Service Notice Number: 20191009-3

**Software update to improve consumable life and 380V performance
on the Flexcut 200 and Flexcut 200CE**

Checking the Version of the Software on the Machine

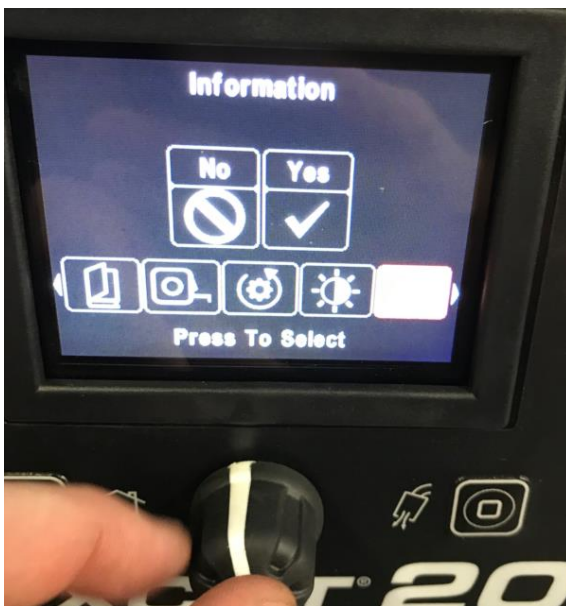
- Press the home and purge buttons at the same time. This will take you to the options menu.
- Use the knob to scroll to the right to the information tab. Press the knob to select 'Information' then turn over to 'Yes' and press the knob again to select.

- This screen will now appear that shows all three software versions in the machine. The 'Power Source' software is the version that is being changed with this update will show S32360-11 for the Flexcut 200 code 12731 and S32922-7 for the Flexcut 200 code 12825 and the Flexcut 200CE code 12829.
